ADDENDUM #3
INVITATION FOR BID #22-46

NEWTON FREE LIBRARY PARKING LOT IMPROVEMENTS

THIS ADDENDUM IS TO ANSWER THE FOLLOWING QUESTIONS AND PROVIDE UPDATED PLAN SHEETS, PROJECT MANUAL PAGES AND CLARIFICATION OF PROJECT MANUAL:

VERTICAL GRANITE CURB SETTING ADJACENT TO GRASS
N.T.S.

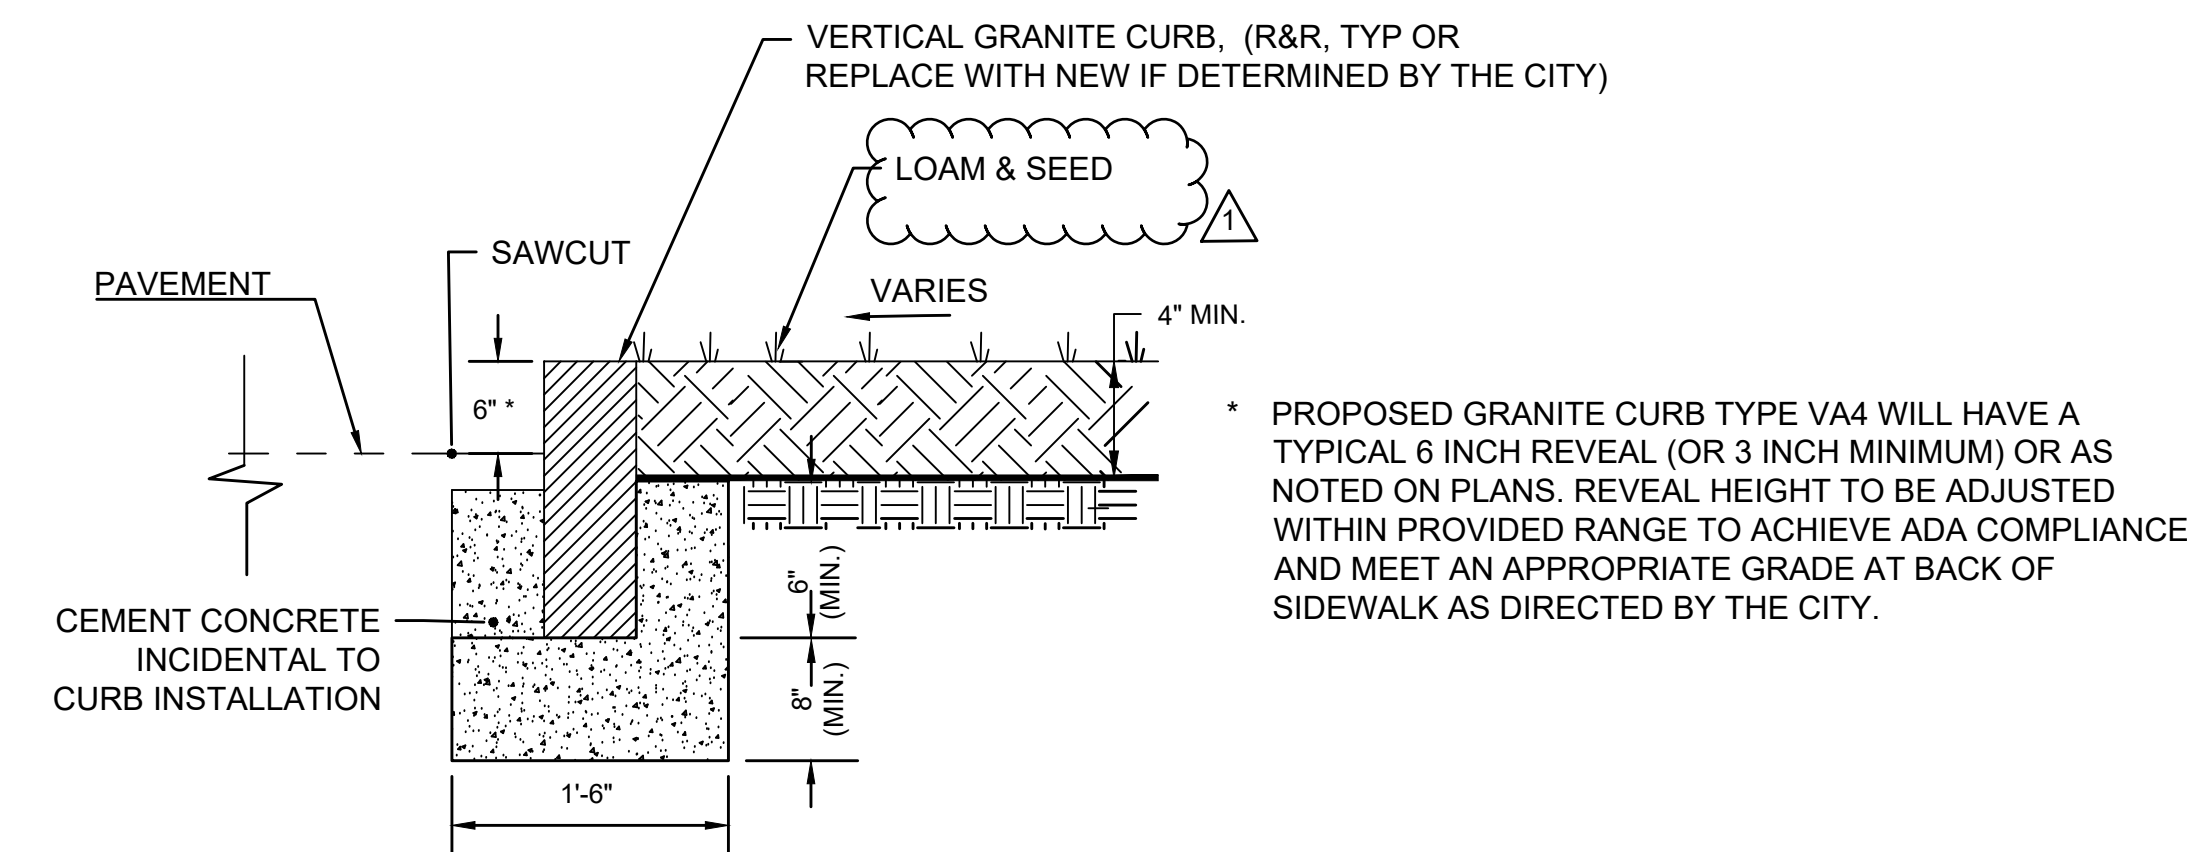
Q10. On detail sheet c-09 vertical curb it states loam by others. Please clarify who is loam and seeding.

A10. Loam and seed shall be installed by the Contractor as part of this contract.

Replace plan set Sheet C-09, Construction Details II, with the attached updated plan sheet. Changes to the "Vertical granite curb setting adjacent to grass" detail incorporated as part of Revision No. 1 are clouded.

POROUS PAVEMENT DETAIL
SCALE: N.T.S.

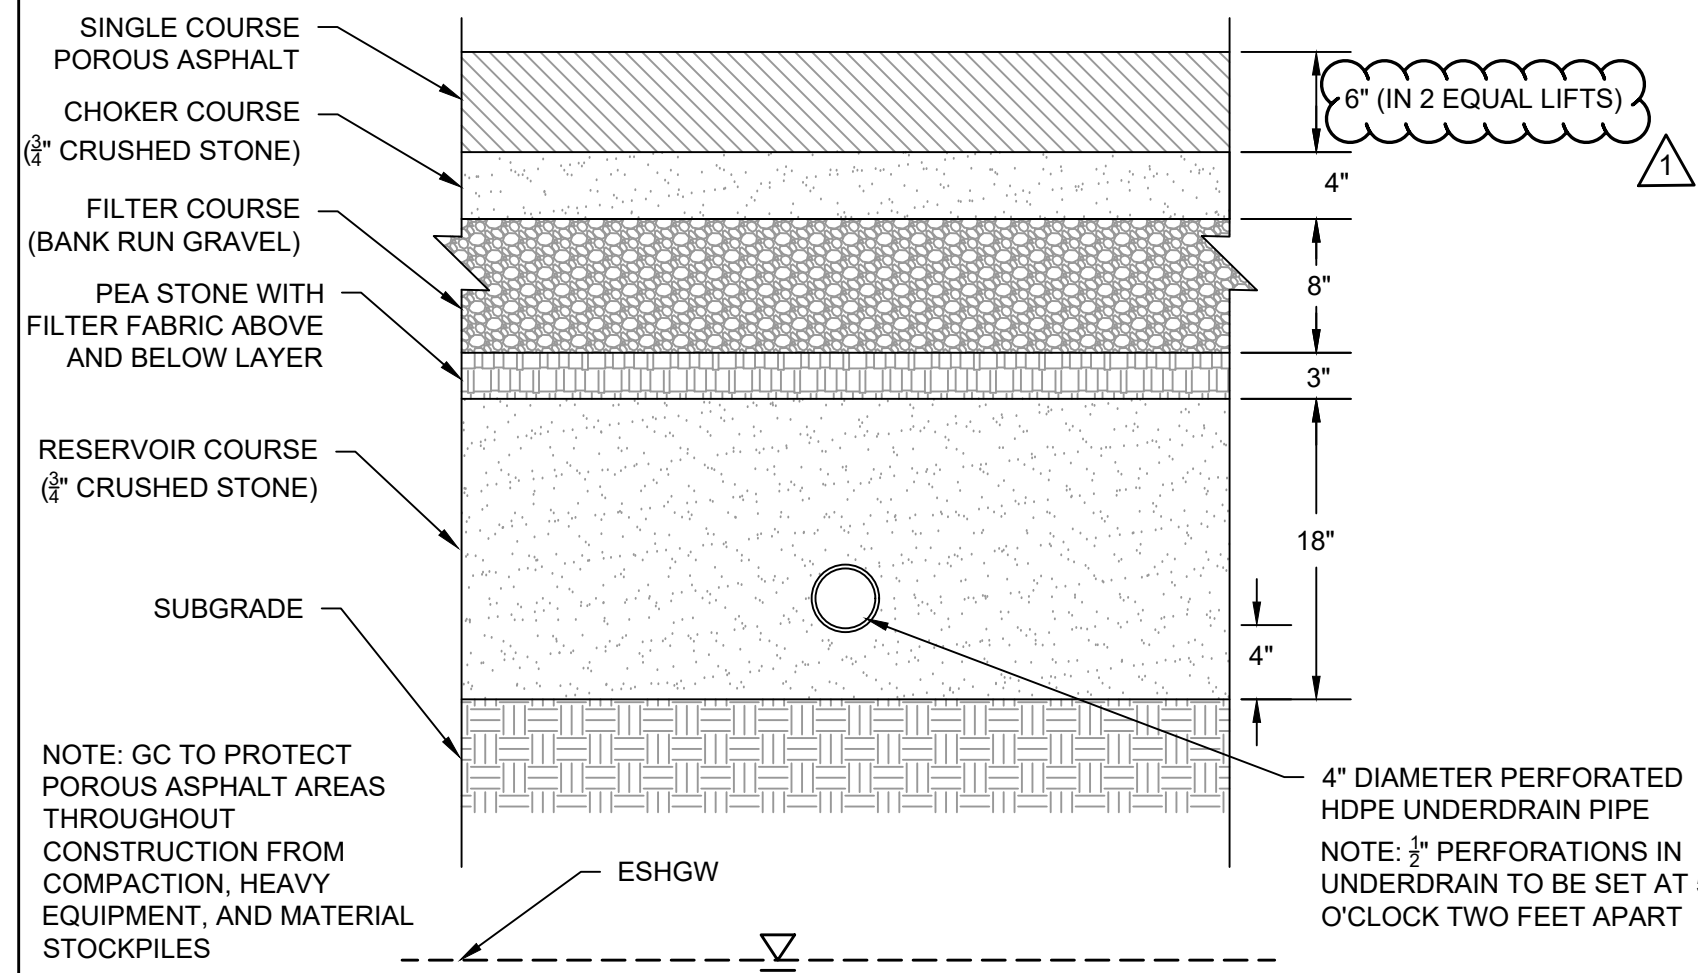
Q8. The porous pavement detail is calling for one 6" lift of porous pavement. Is this correct?

A8. The porous pavement shall be placed on two equal lifts. As specified on page 156 of the Project Manual, Section B – Porous Asphalt Pavement Installation, Subsection 7 – Spreading and Finishing, "The Porous Asphalt shall be placed either in a single application at 4 inches thick or in two lifts."

Sheet Name:
Enlargement Plan 1

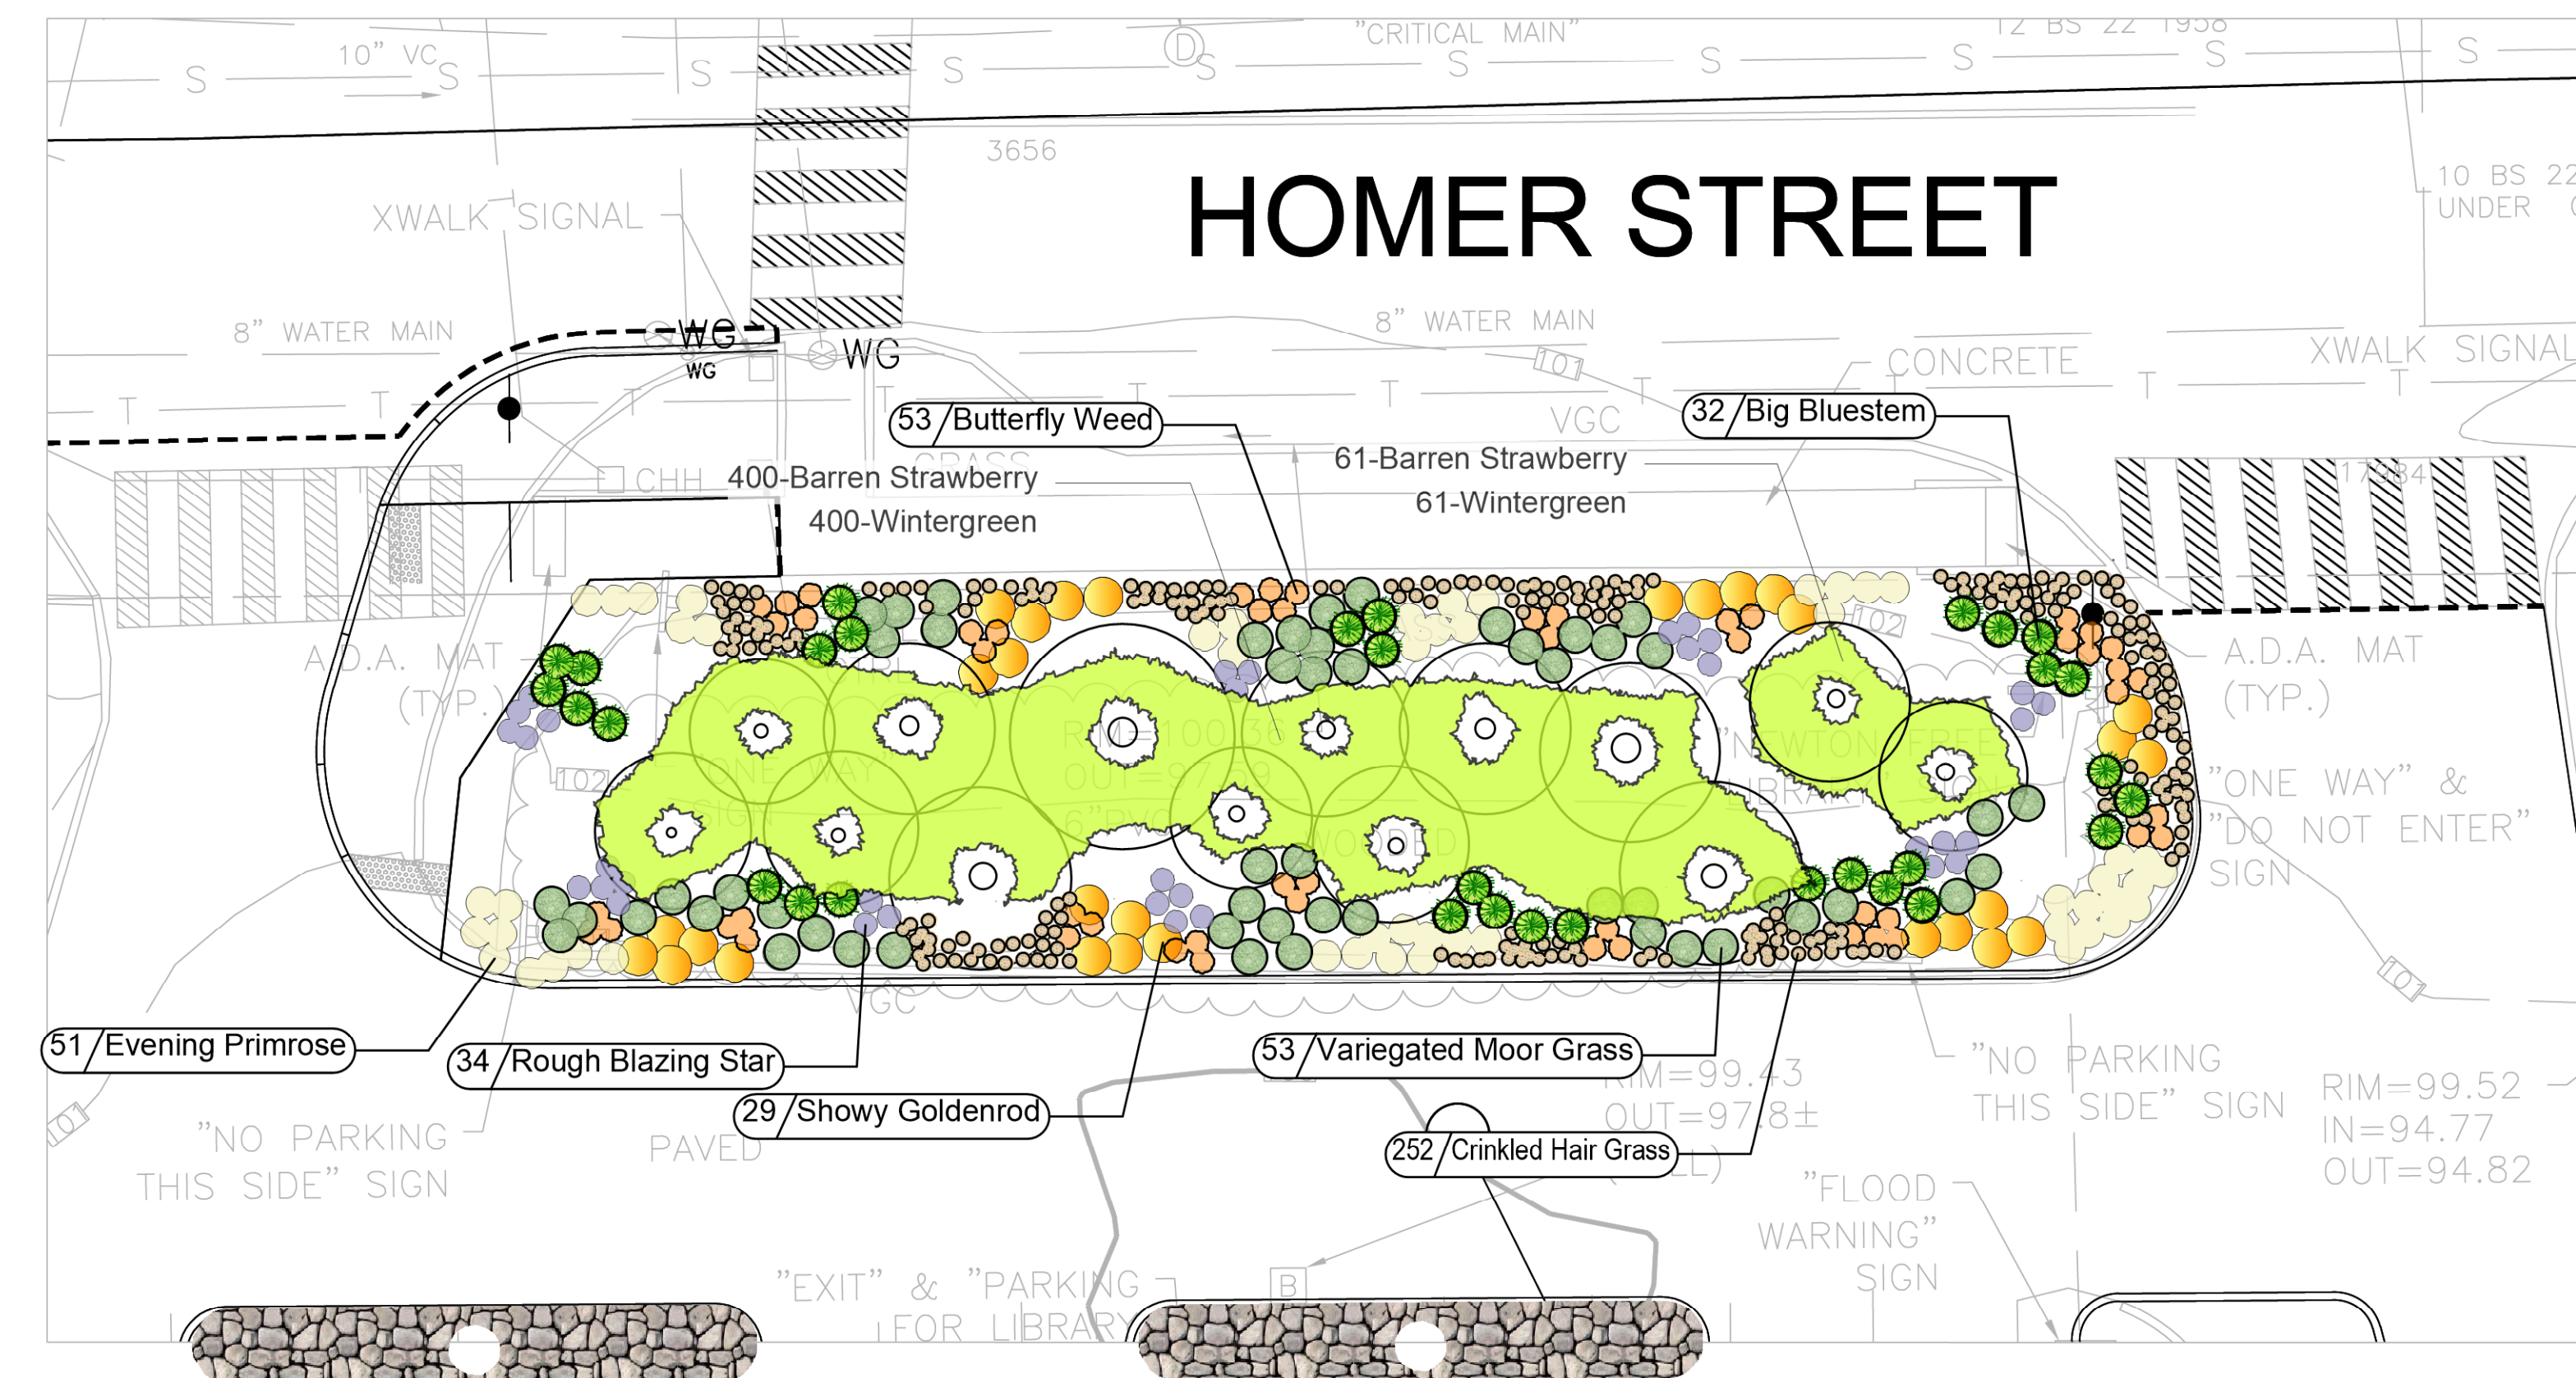
Q5. Item 799 "landscaping" includes two crushed stone surface islands. What size stone is this and how thick is it getting installed?

Q6. The planting schedule on drawing L1 has some different quantities than what is called out on all the landscape drawings. Some quantities are higher and some are lower. Since this is a lump sum item are we supposed to base it off the quantities in the planting schedule or the quantities called out on the drawings?

A5. The two proposed crushed stone surface islands shown on Sheet L1 shall be constructed with 6-inch-deep, ¾"-diameter washed crushed stone. Crushed stone will be paid for under Item 799. Landscaping.

A6. The quantities for the planting should be based on the landscape drawings instead of the planting schedule.

Replace plan set Sheet L1, Enlargement Plan 1, with the attached updated plan sheet; changes made to the Planting Schedule table as part of Revision No. 1 are clouded.

LIGHTING PLAN

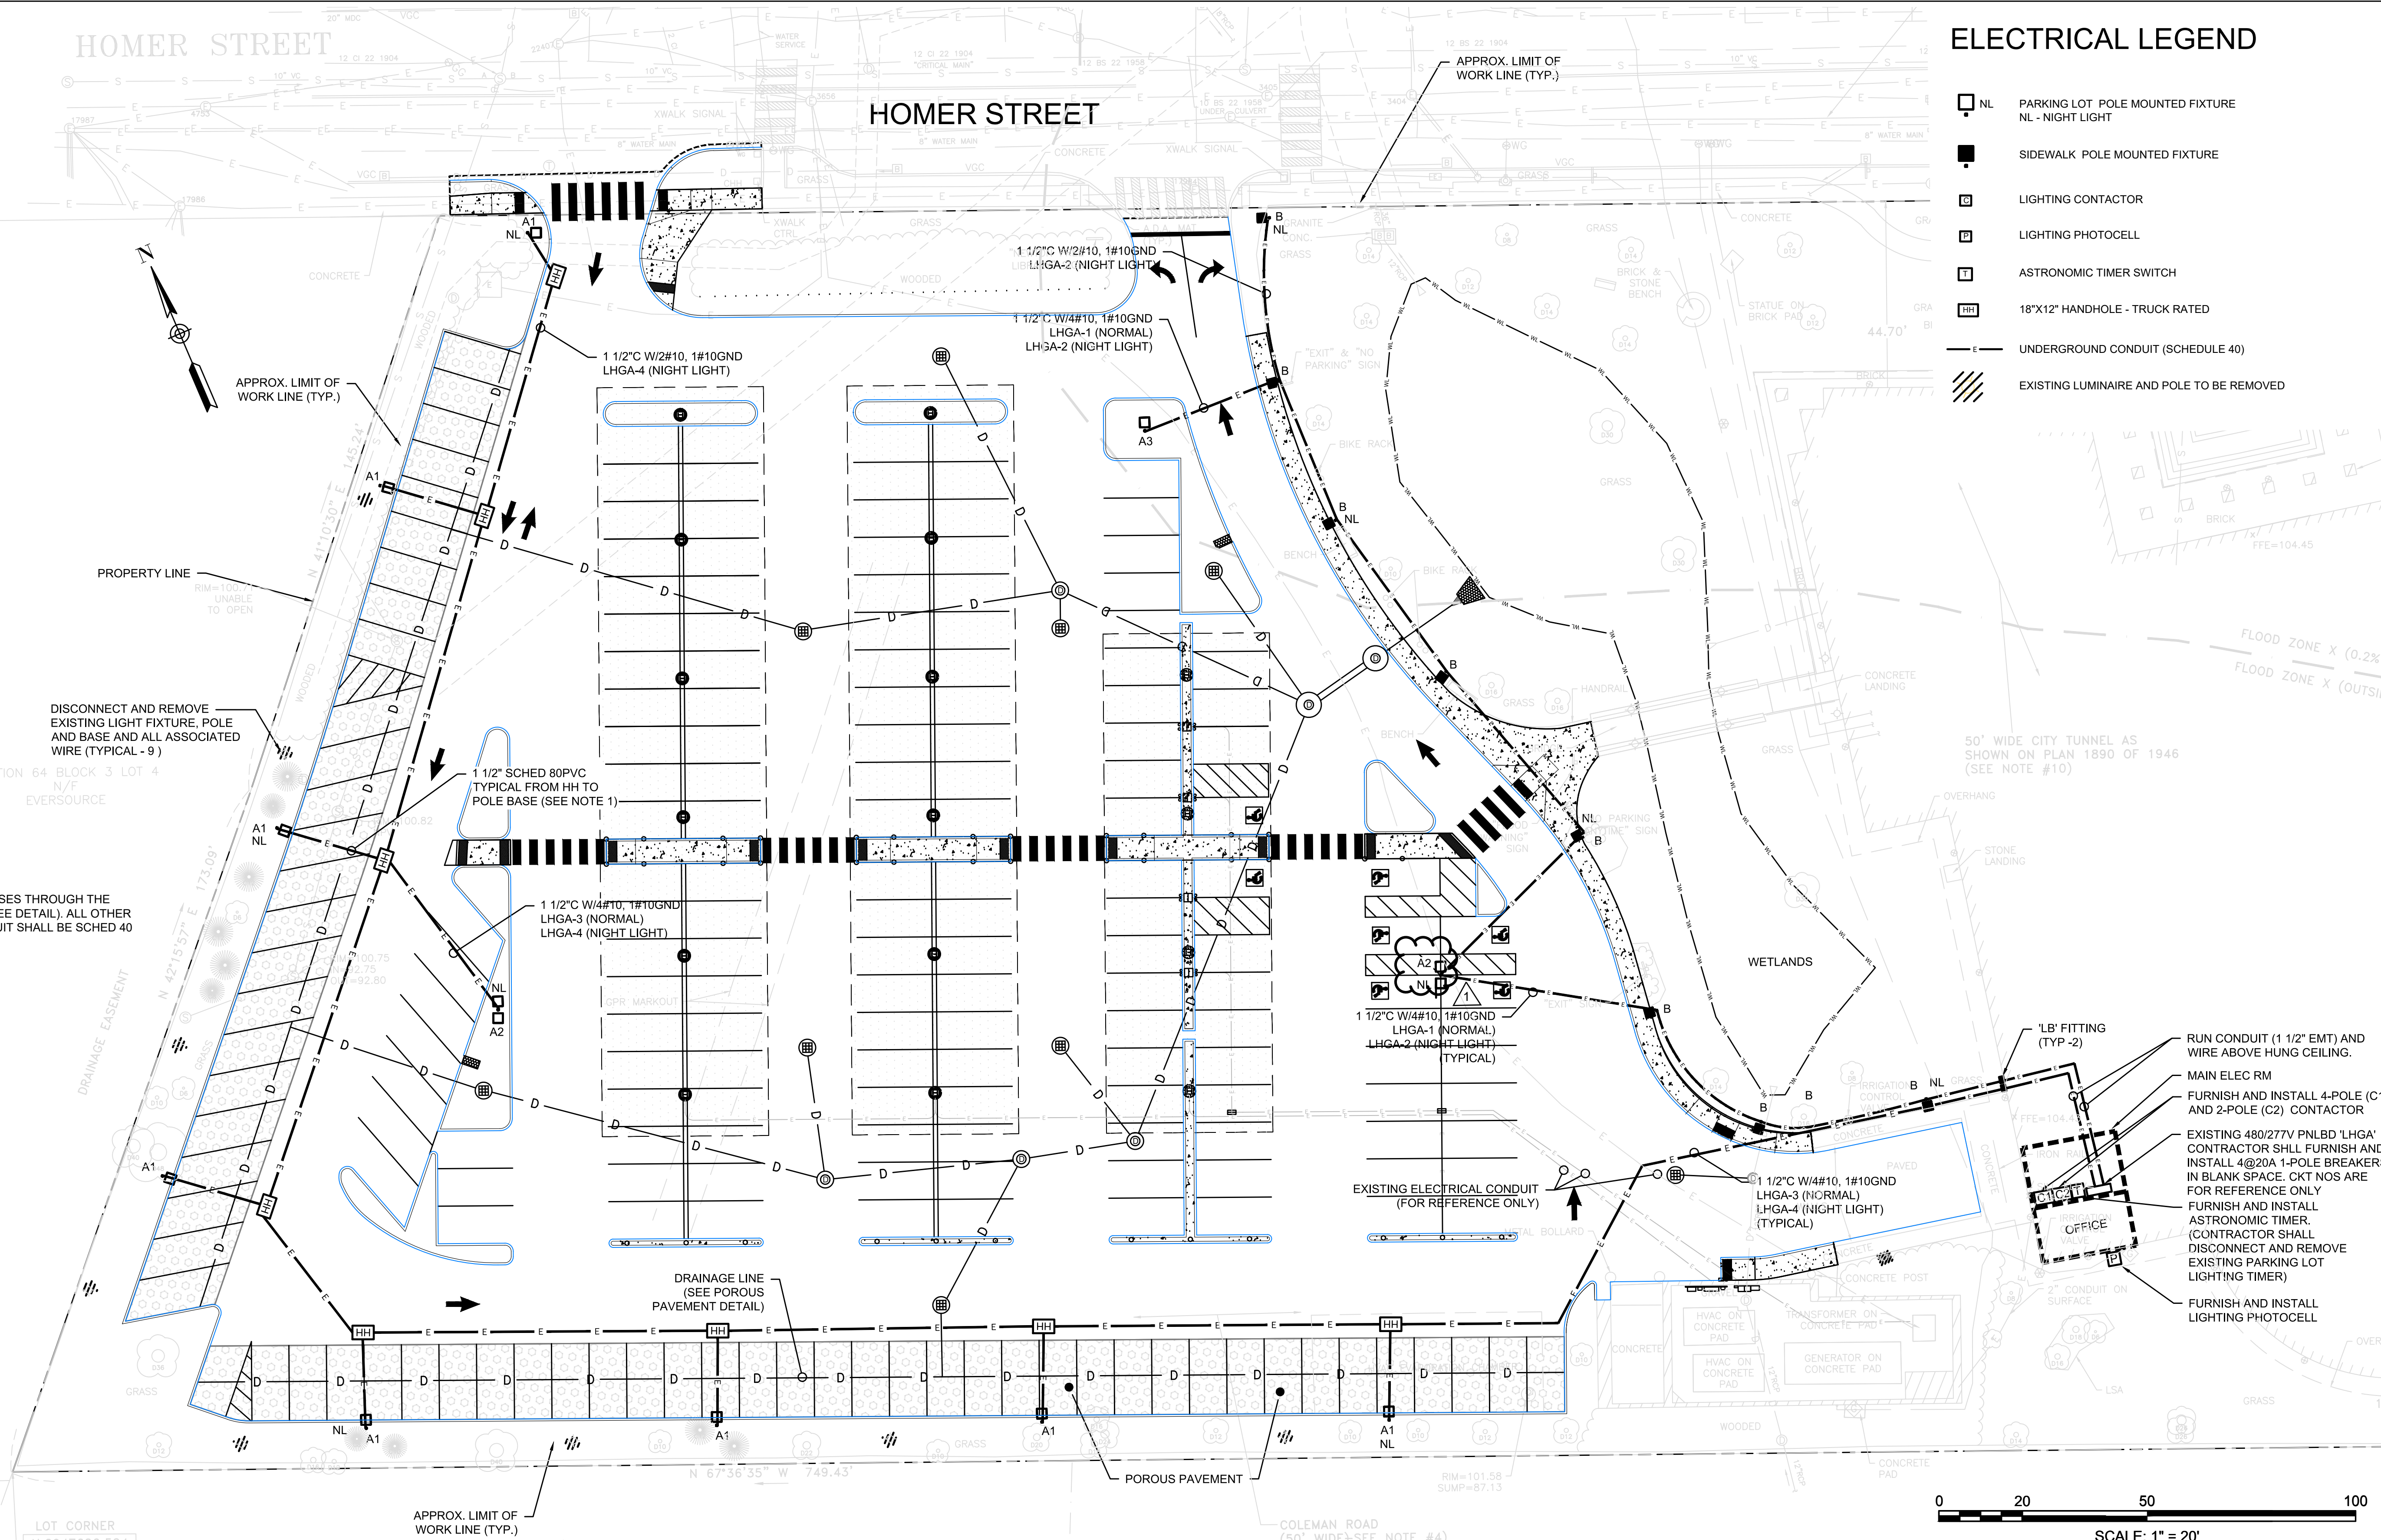
Q12. Type A3 lighting is described as a single in the LIGHT FIXTURE SCHEDULE shown on drawing E-02. On lighting plan E-01, A3 is shown as a double. Which is correct?

Q13. Item 811.27 ELECTRIC HANDHOLE (MUNICIPAL STANDARD) has a bid quantity of 18. Drawing E-01 shows a quantity of 8. Which is correct?

A12. The correct label for the double luminaire should be A2.

Replace plan set Sheet E-01, Lighting Plan, with the attached updated plan sheet, with changes incorporated as part of Revision No. 1 clouded.

A13. The correct quantity for Item 811.27 Electric Handhole (Municipal Standard) is 8.
